**Planning & Environment**
Issued under the Environmental Planning and Assessment Act 1979
Approved Section 4.55 (.....) Modification Application
No. 3 granted on the 8 May 2019
in respect to SSD 7484
Signed AD
Sheet No. 1 of 33

PROJECT
**SANDSTONE
PRECINCT**
23-39 BRIDGE STREET, SYDNEY 2000, AUSTRALIA

PROPOSED SITE PLAN

DRAWING NUMBER
SP-DA-G-1500

DRAWING
PROPOSED PLANS
LANDS BUILDING - GROUND, EDUCATION BUILDING - LOWER GROUND

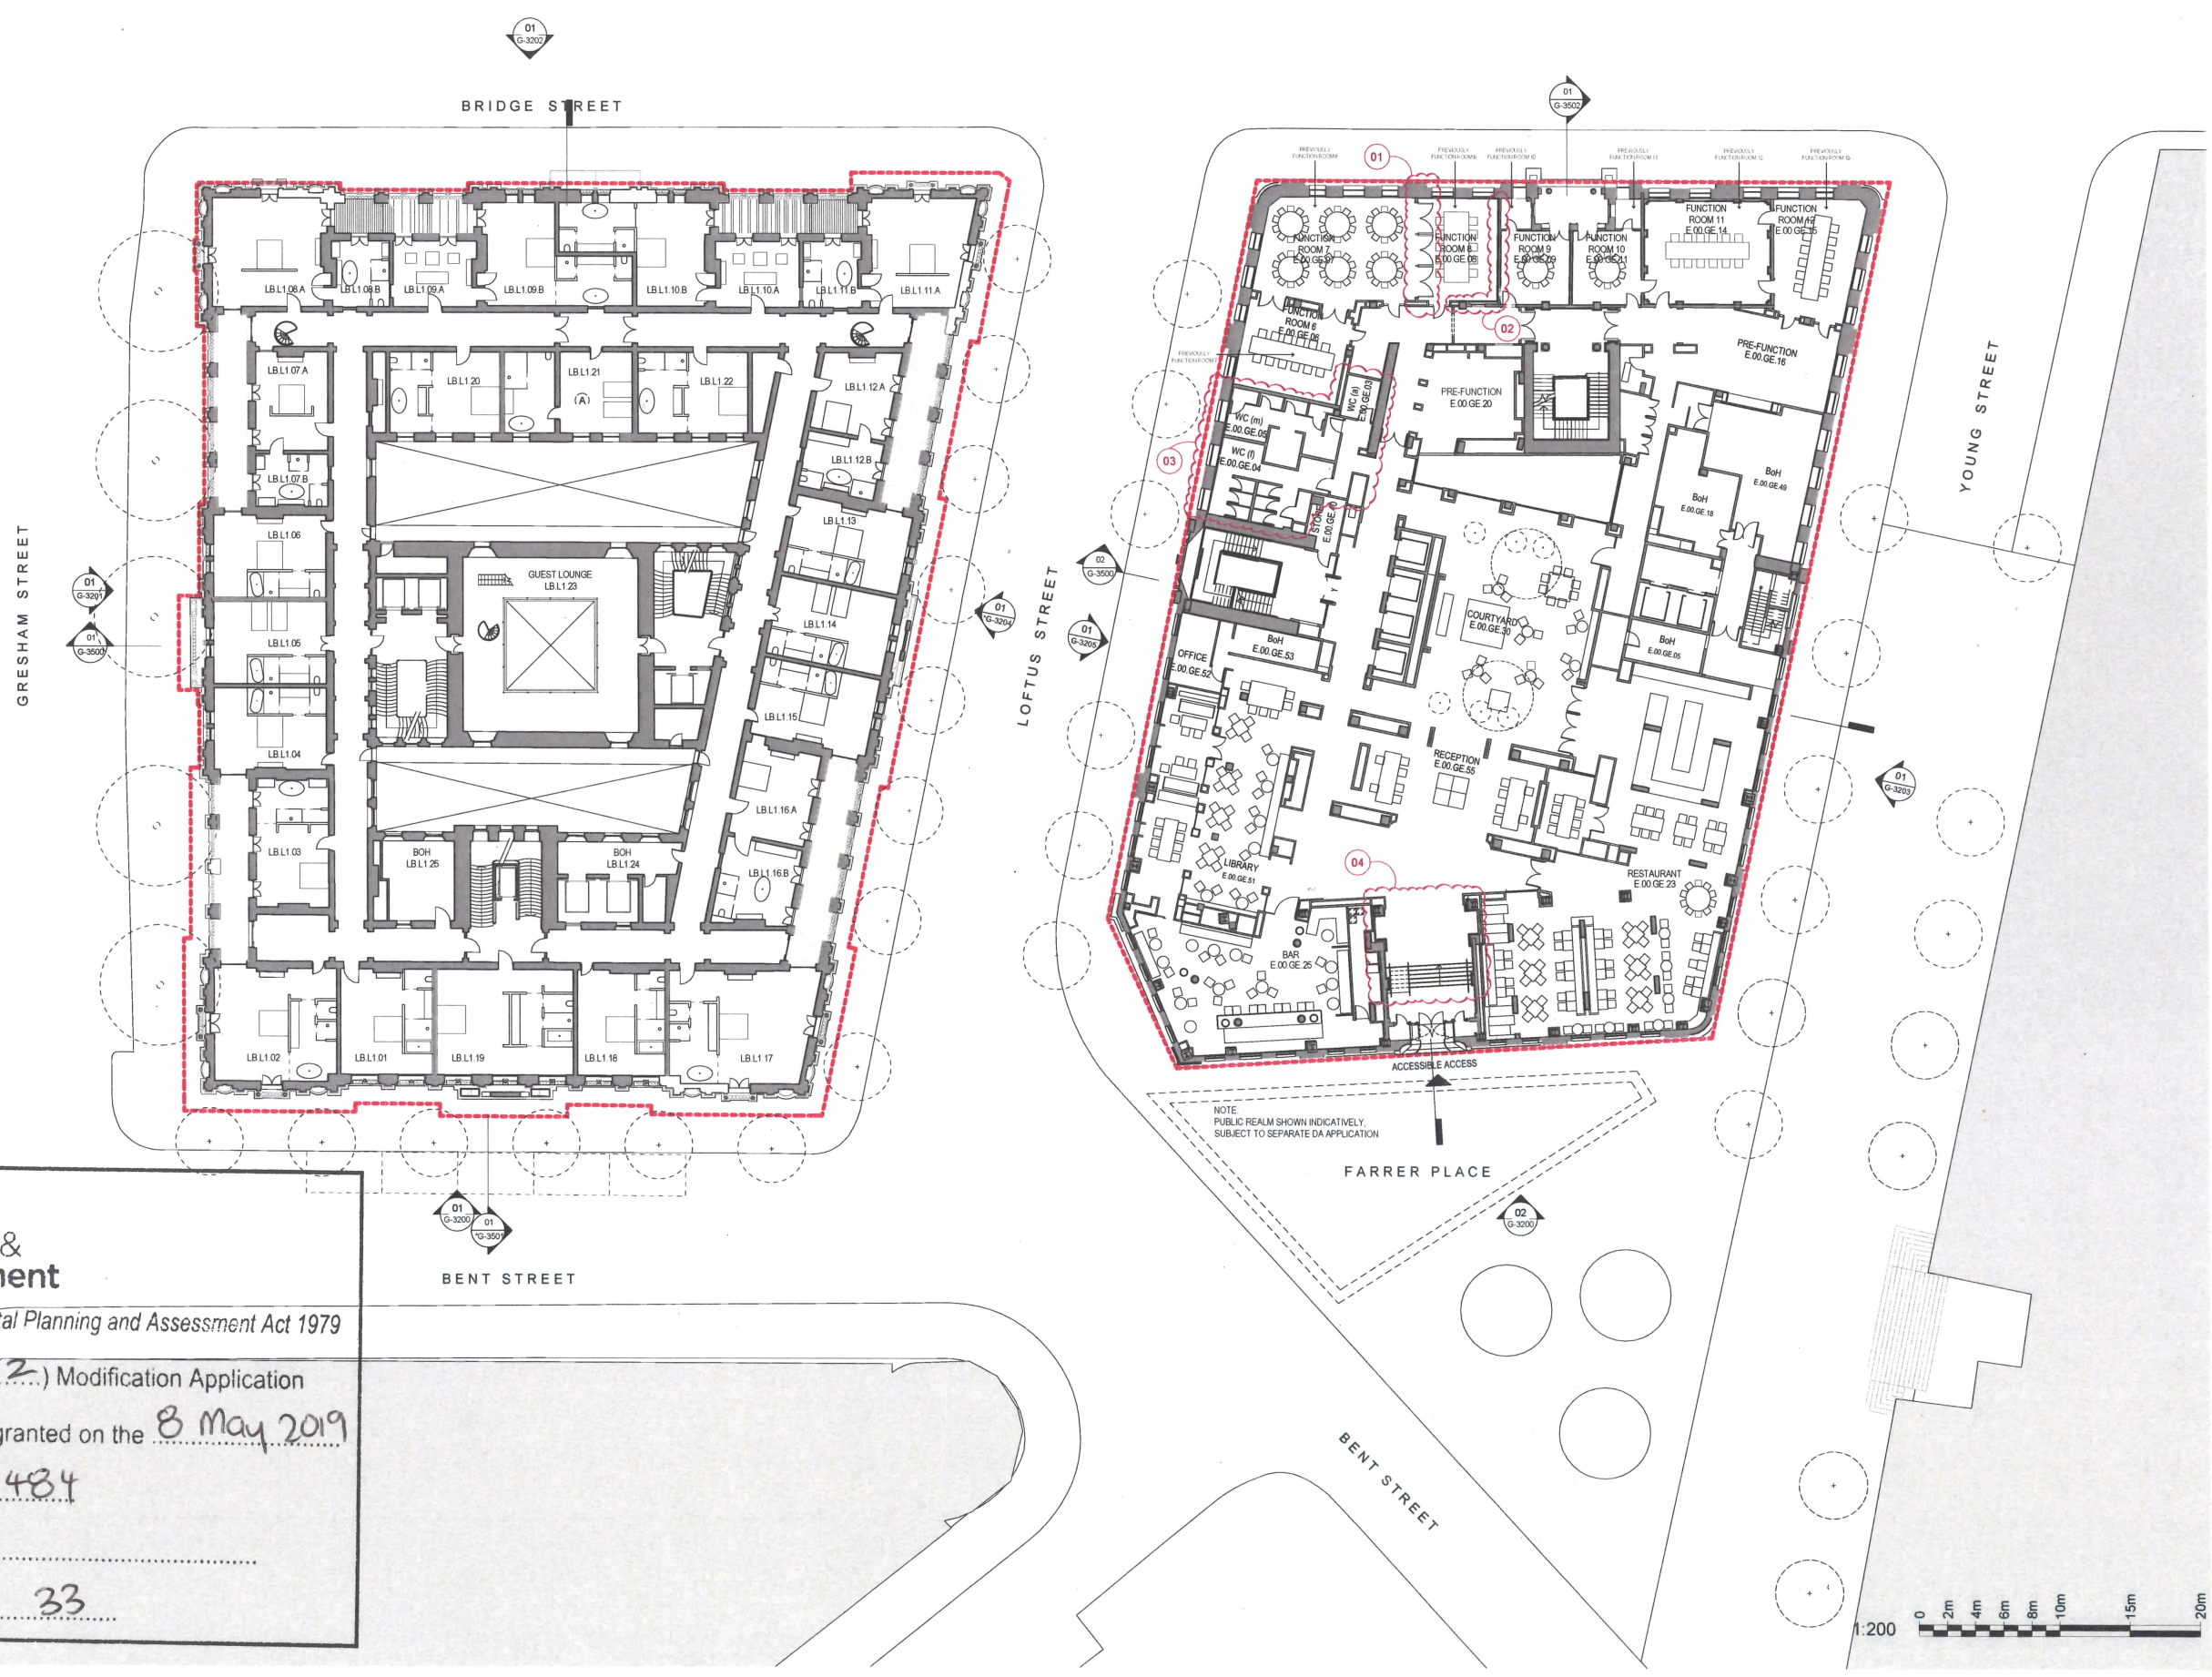
- LEGEND
- SITE BOUNDARY
 - ▲ PRIMARY ENTRANCE
 - ▲ SECONDARY ENTRANCE
 - ▲ STAFF ENTRANCE
 - ACCESSIBLE ROOM
 - W WASTE
 - R RECYCLING
- LANDS BUILDING KEY COUNT: 19
- CHANGES LEGEND:
- 01 REMOVAL OF BALLROOM
 - 02 REDUCTION OF 4 BOH LIFTS TO 2 FROM THE BASEMENT LEVELS TO FARRER PLACE
 - 03 LOADING BAY RELOCATED
 - 04 PRE-FUNCTION SPACE RELOCATED FROM WEST. ADDITIONAL FUNCTION AND PRE-FUNCTION AREAS CREATED - HOME KITCHEN AND TRIPLE HEIGHT SCULPTURE GARDEN
 - 05 ADDITIONAL FUNCTION ROOM
 - 06 EASTERN ESCAPE STAIR AND STAFF ENTRY RELOCATED TO INCREASE SPACE AT FARRER PLACE LEVEL FOR THE RESTAURANT
 - 07 SECONDARY LUGGAGE ENTRANCE AND STORAGE
 - 08 RECONFIGURED BOH AREA
 - 09 HERITAGE WALL RETAINED AS PER C08S HERITAGE OFFICER REQUIREMENTS

**LANDS BUILDING - LEVEL 01,
EDUCATION BUILDING -
GROUND**

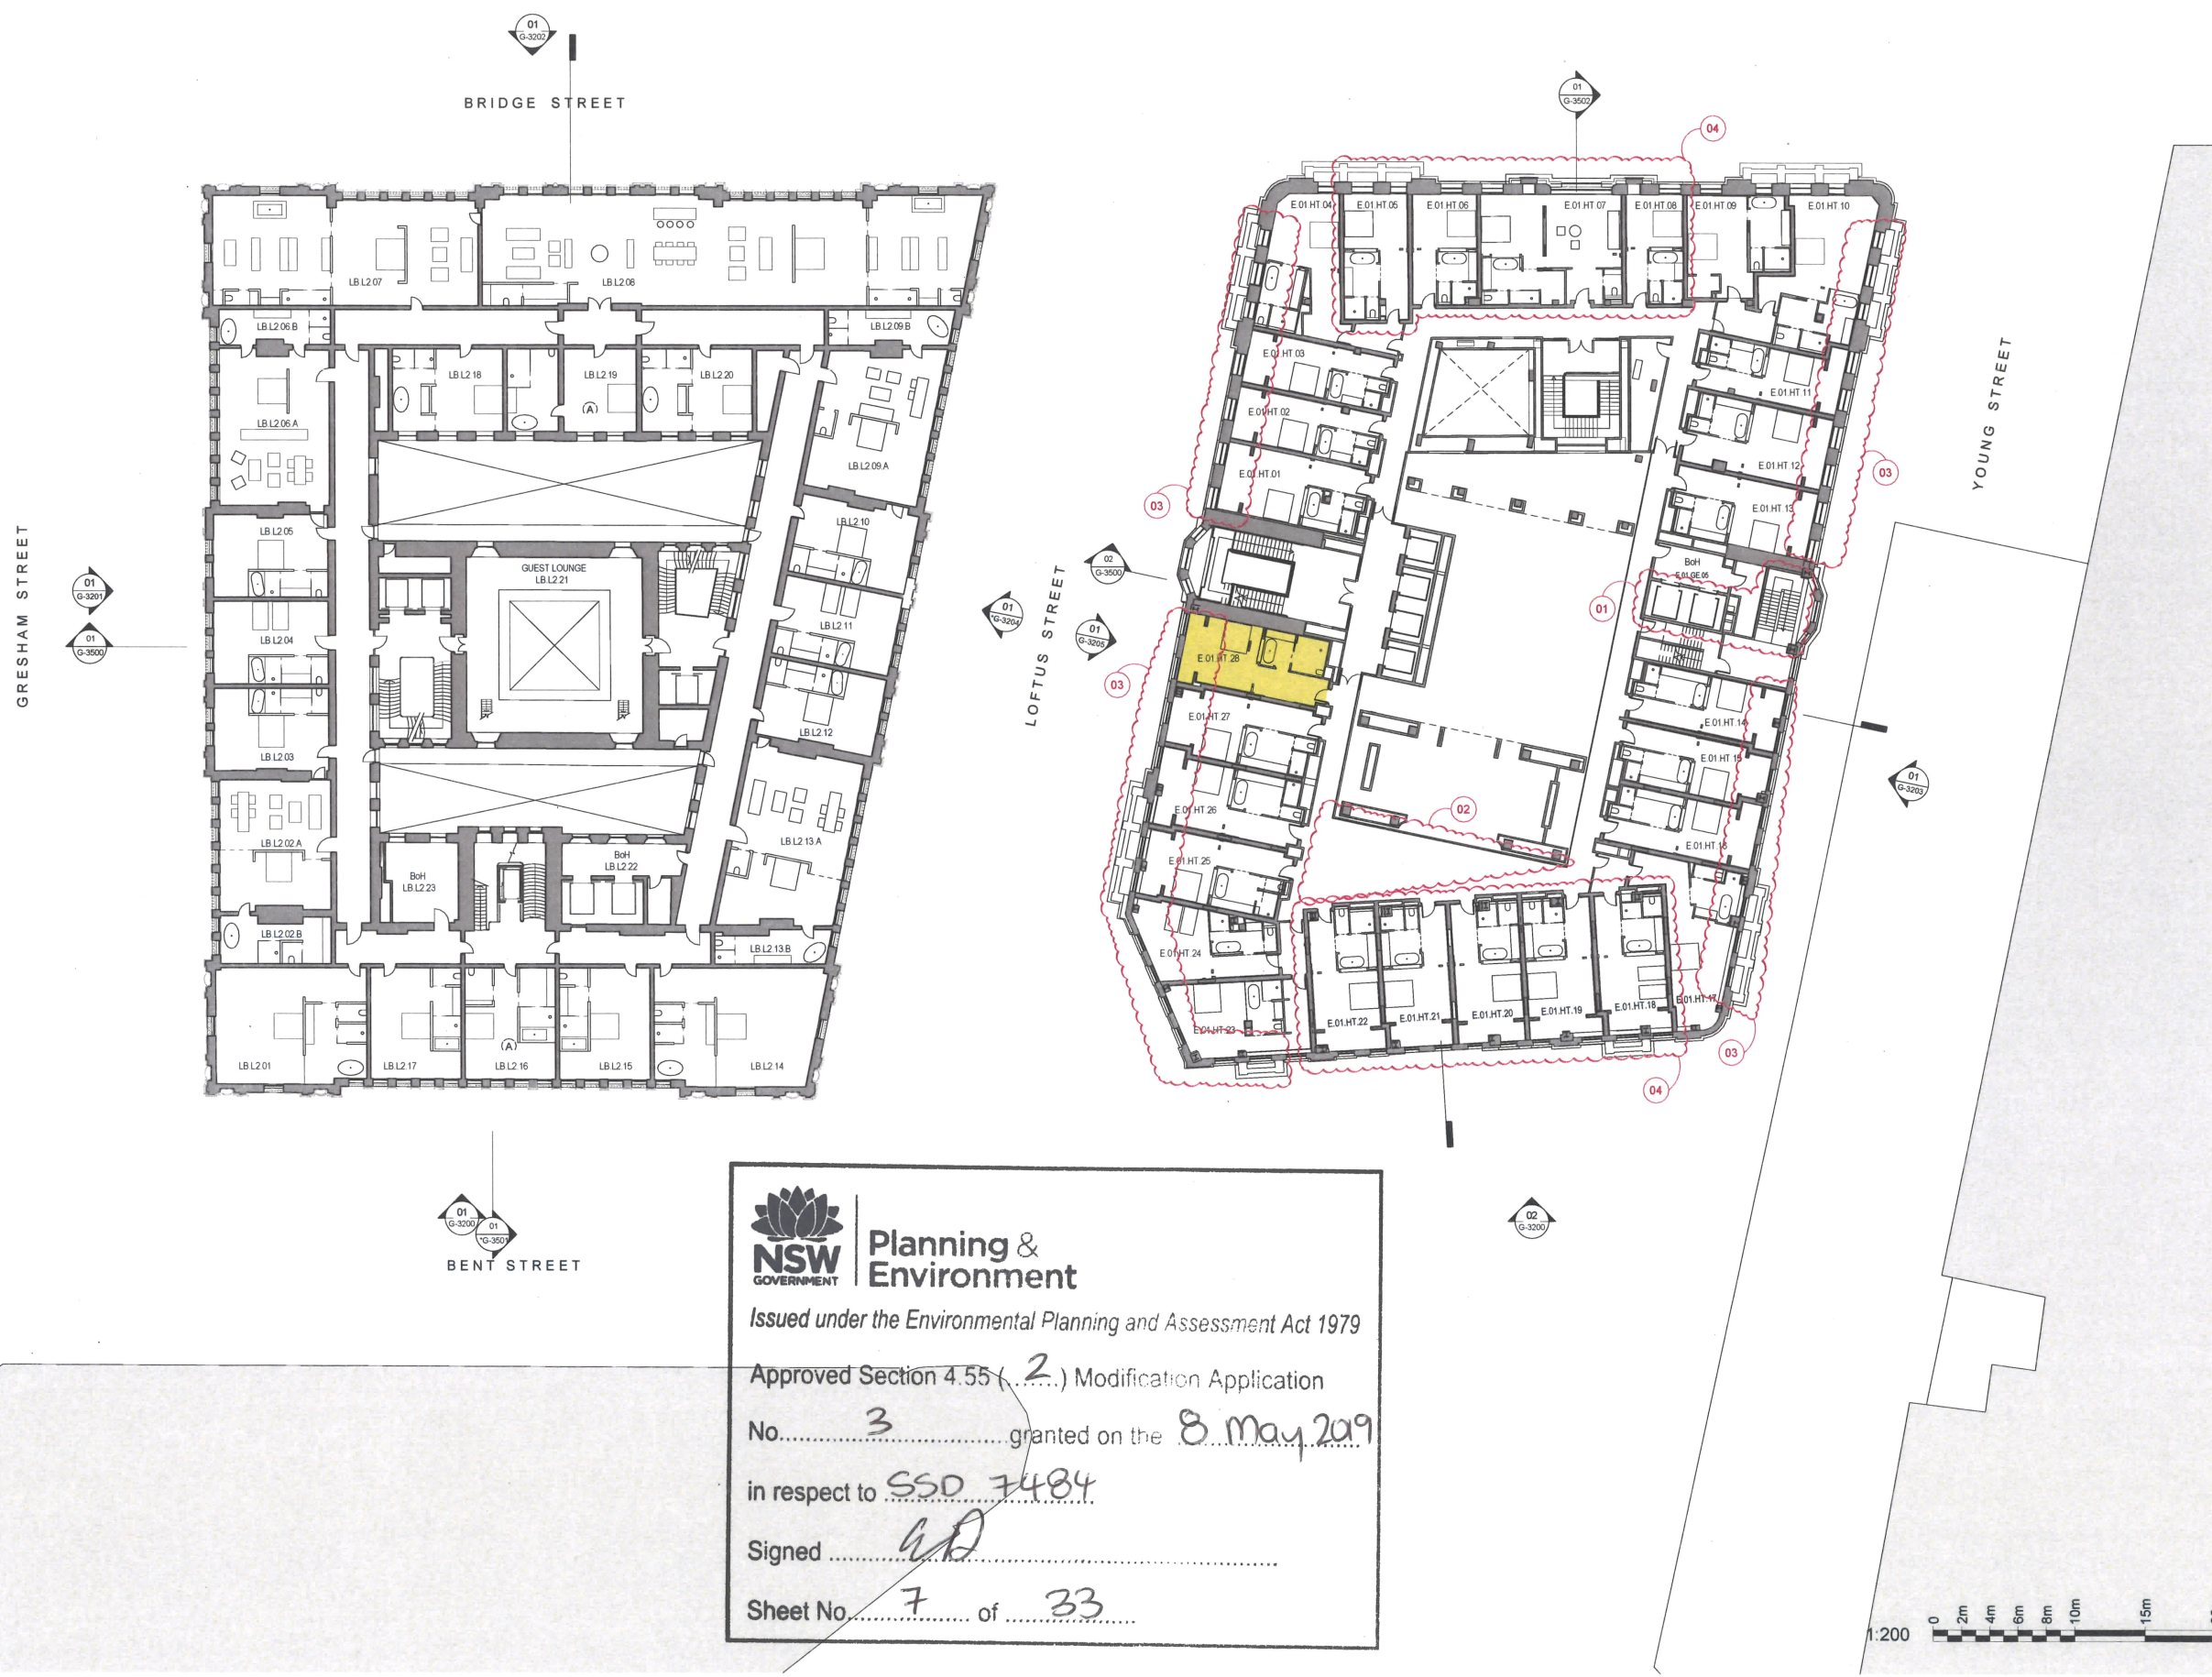
- LEGEND:
- SITE BOUNDARY
 - ▲ PRIMARY ENTRANCE
 - ▲ SECONDARY ENTRANCE
 - ▲ STAFF ENTRANCE
 - ACCESSIBLE ROOM
 - W WASTE
 - R RECYCLING
- LANDS BUILDING KEY COUNT: 22
- CHANGES LEGEND:
- 01 NBS, BULKHEAD AND OPERABLE WALL ADDED
 - 02 HERITAGE DOOR LOCKED OFF AND PRESERVED INSITU
 - 03 REVISED PUBLIC WC LAYOUT
 - 04 WALL LINE PUSHED BACK TO REVEAL MORE OF EXISTING MARBLE COLUMN FABRIC

**LANDS BUILDING - LEVEL 02,
EDUCATION BUILDING -
LEVEL 01**

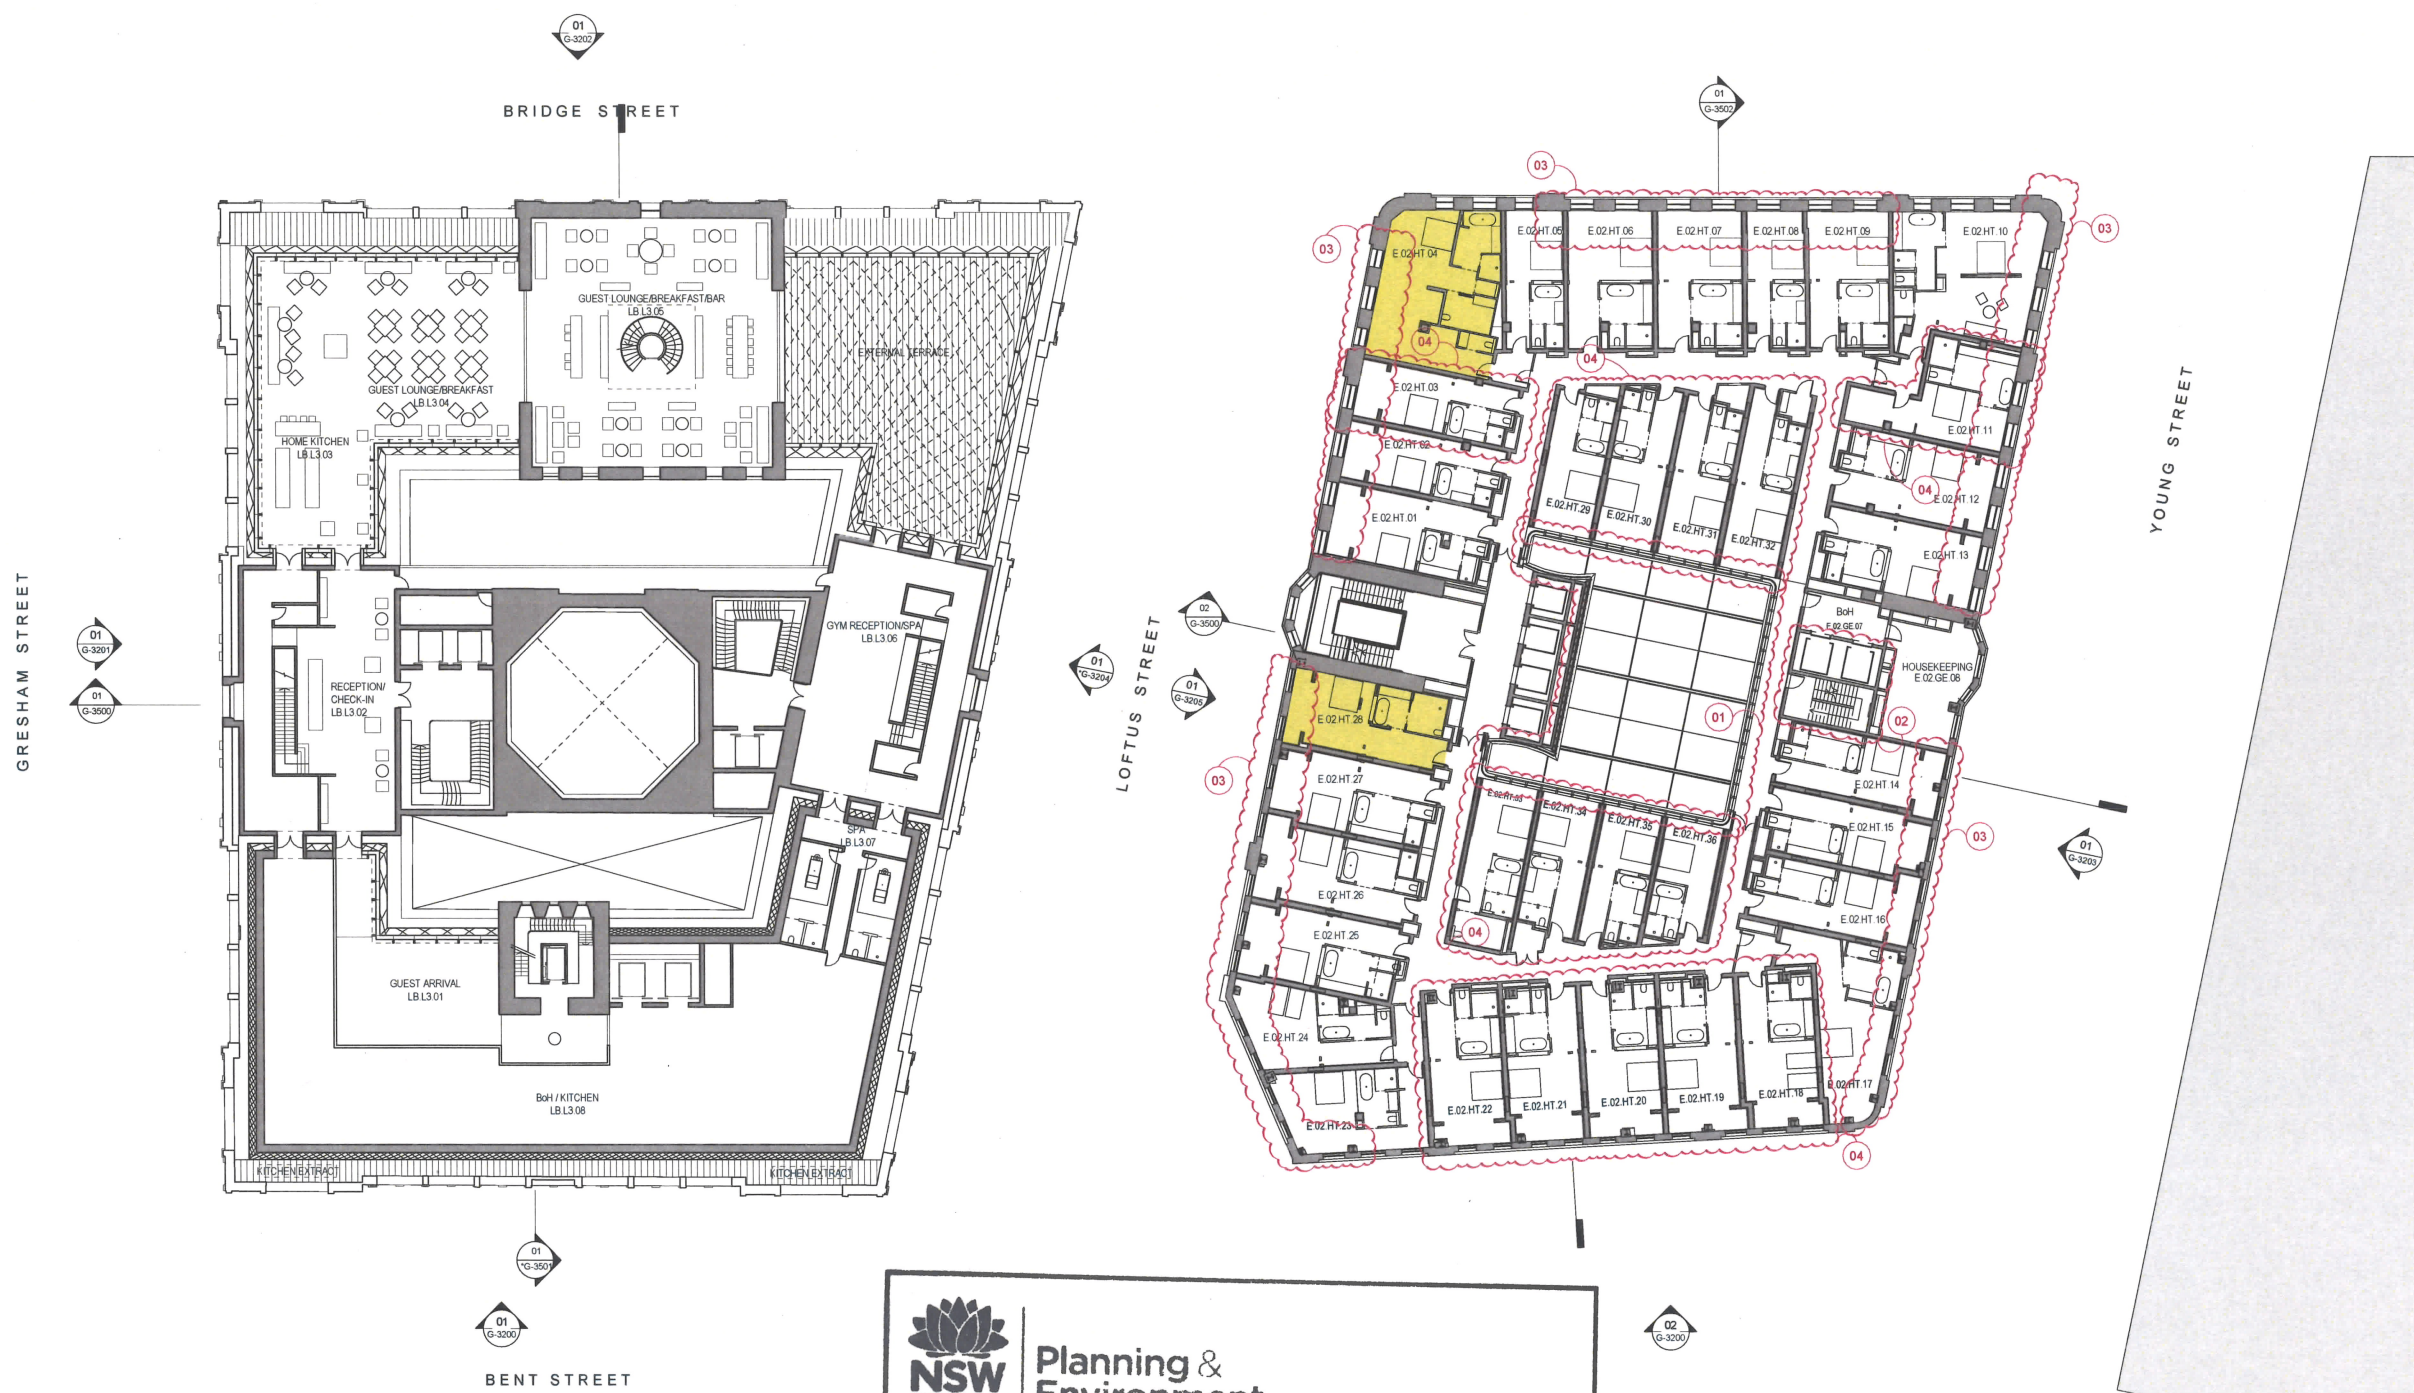
- 01 BOH LIFTS AND STAIR MOVED NORTH TO CREATE A MORE EFFICIENT CORE
- 02 COURTYARD FULL HEIGHT FACADE REPLACED WITH BALUSTRADE. EXTERNAL TERRACE REMOVED.
- 03 WINTER GARDENS REMOVED AND SECONDARY GLAZING INSTALLED
- 04 ADDITIONAL KEY
